Arlington Conservation Commission

Date: Thursday, April 2, 2020

Agenda

Notice of Intent: 93 Sunnyside Ave (continued from 2/27/2020)

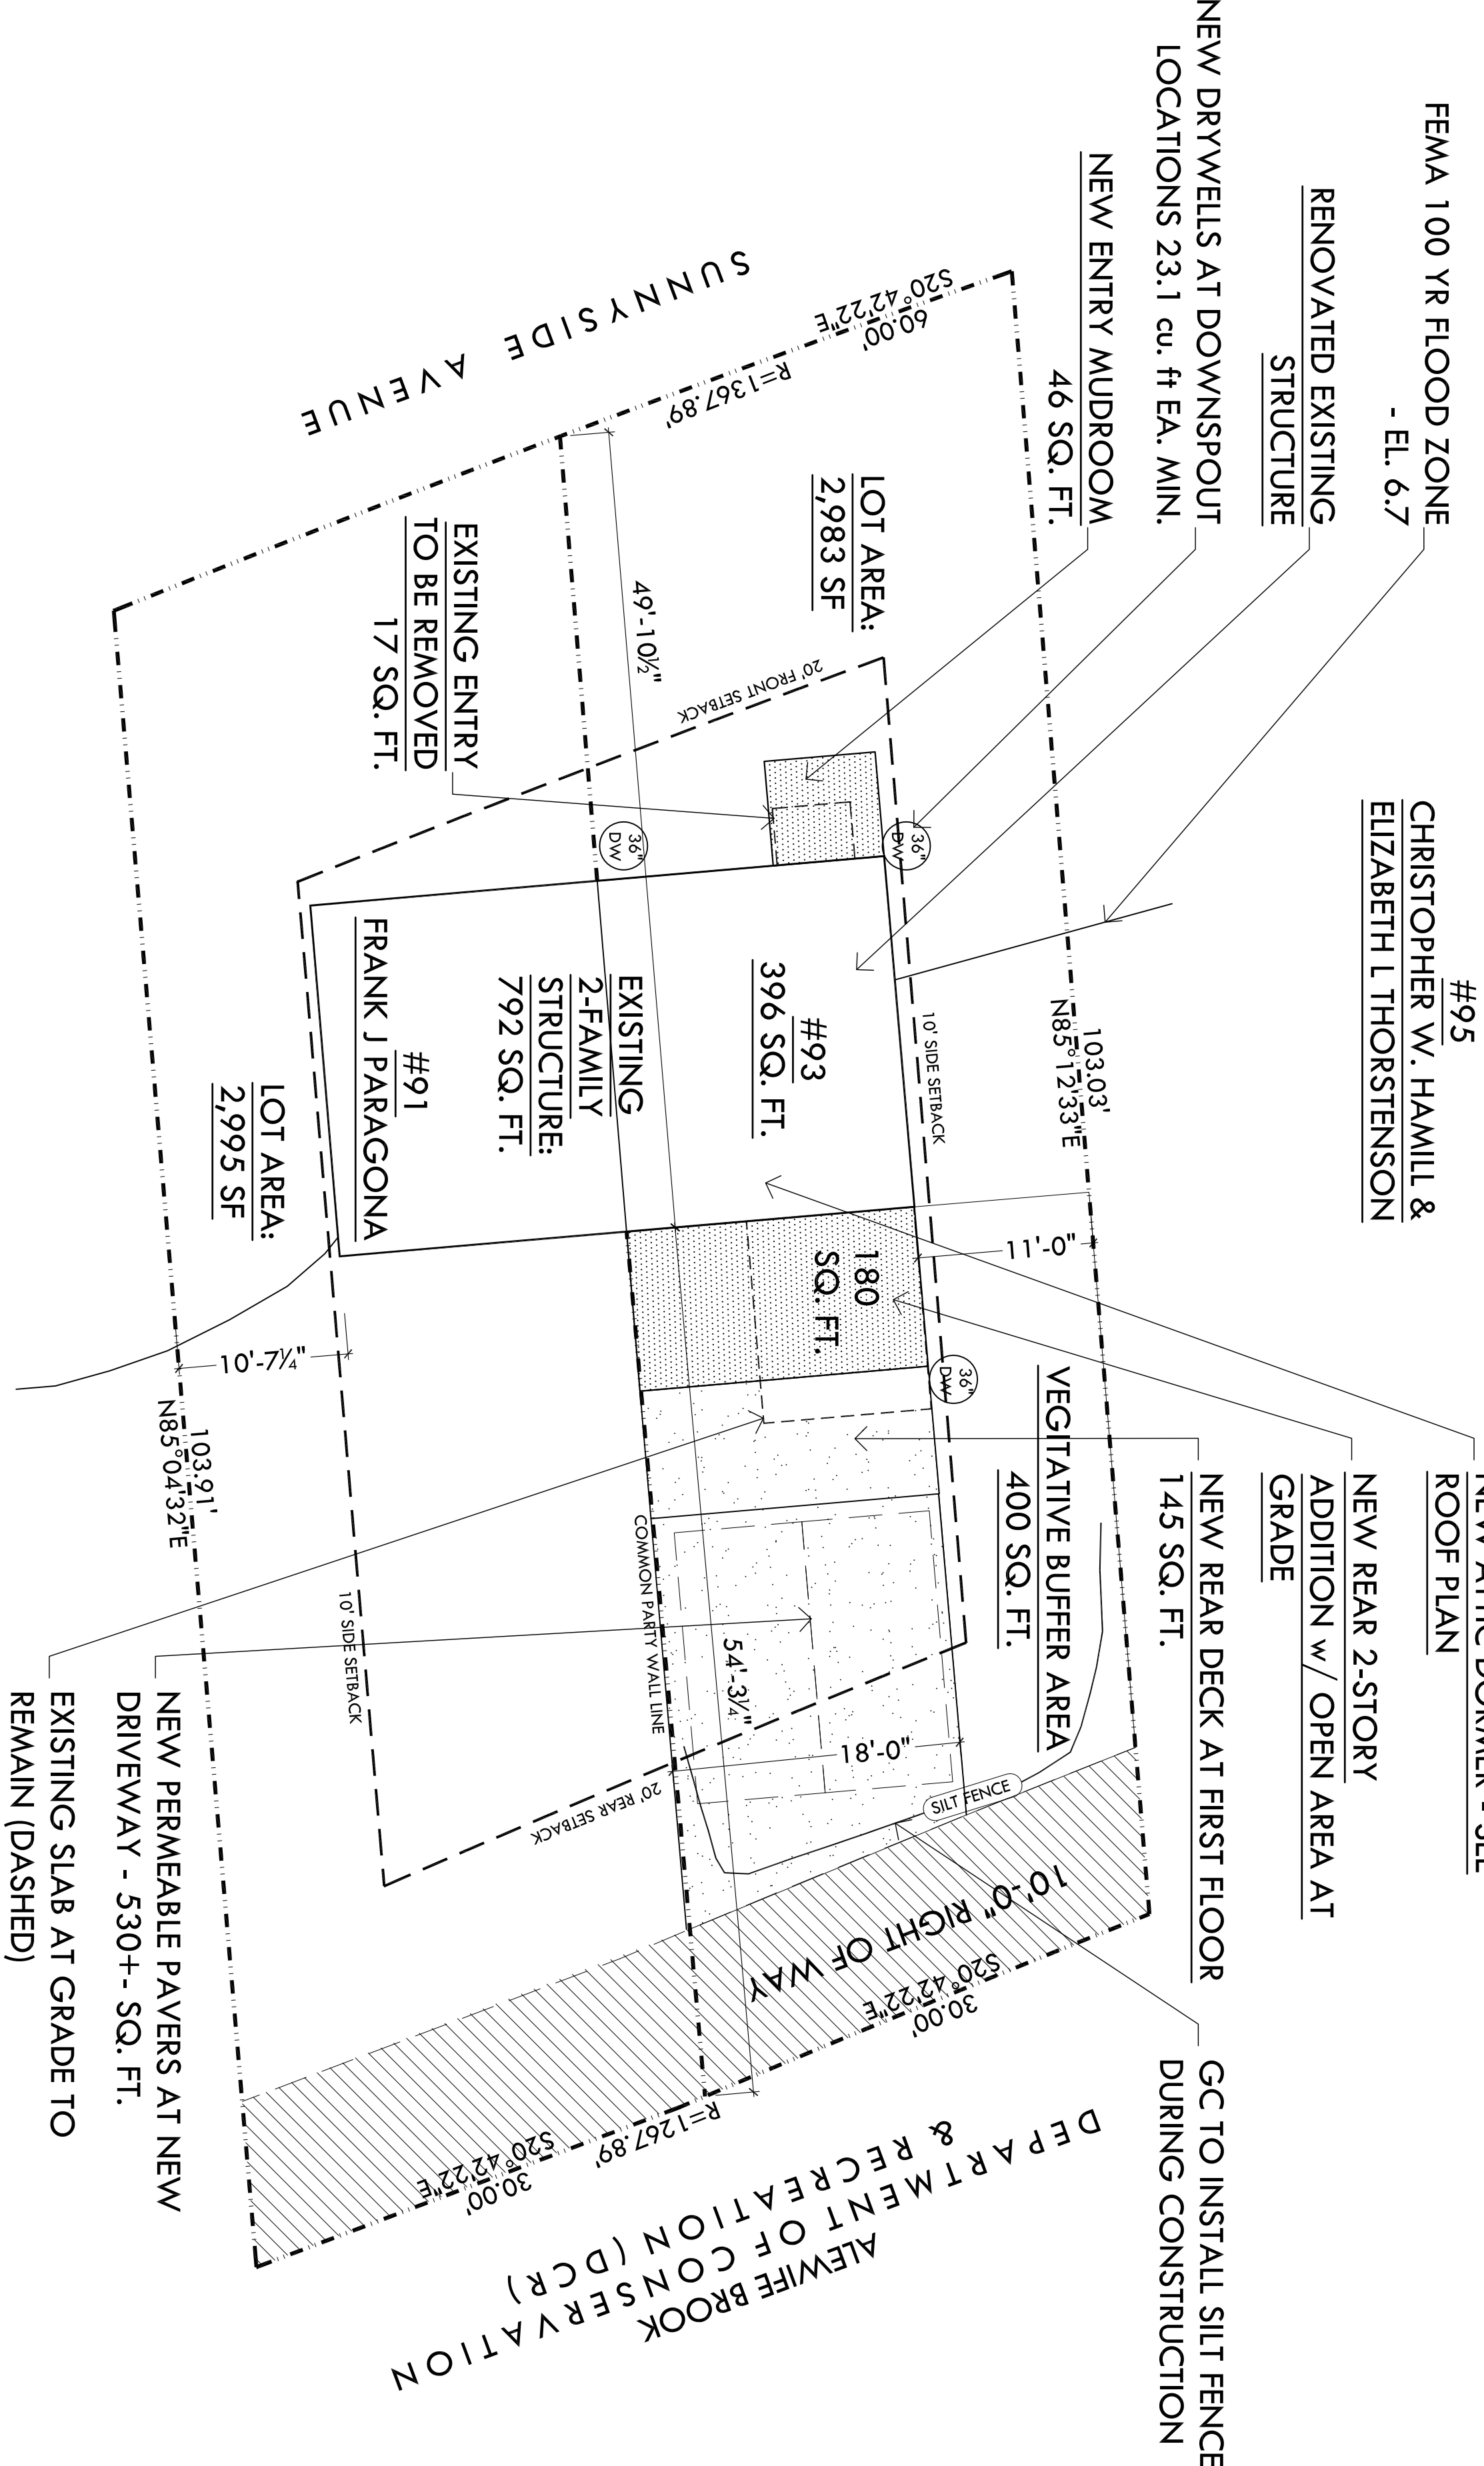
P. Heidell asked how large the proposed driveway is because the narrative and plan say different sizes. T. Blanchard stated the driveway is proposed to be 530 square feet. P. Heidell recommended shrinking the driveway size to allow more room for vegetated area.

C. Tirone asked the Applicant to clarify the proposed compensatory flood storage. T. Blanchard stated that the compensatory flood storage is proposed to be on the site yard of the property, at approximately the same elevations of encroachment. C. Tirone requested that the elevations at which the flood storage is being proposed be clarified.

D. Kaplan asked whether the water table was high. T. Blanchard stated that the water table was likely high, though he had not conducted testing to determine where exactly the water table is. D. Kaplan asked whether the proposed three dry wells would be above the water table. T. Blanchard stated that the two dry wells proposed in the front yard of the property would be above the water table. The third dry well in the backyard is more questionably above the water table. C. Tirone requested that an alternative to the third dry well be proposed in the event that the water table is too high for the third dry well currently proposed.

L. Cooney stated that the proposed pervious driveway size has been reduced from 530 square feet to 466 square feet. L. Cooney also stated that the proposed vegetated buffer area would be planted with plants including Swamp Milkweed, Beebalm, Joe-pye Weed, Star Flower, and native ferns.

1. **New Driveway Design:** Driveway is reduced to 466 sq. ft. allowable for side-by-side parking for two compact cars. See attached site plan A2.1A.
2. **New compensatory flood storage design at same elevation as encroachment:** See site plan A1.0 & A4.0.
3. **Alternative for the backyard drywell in the event that the water table is too high:** If ground water is too high, new perforated VC French drain system will be installed that will direct water run off to vegetation buffer area. See site plan A2.1A.
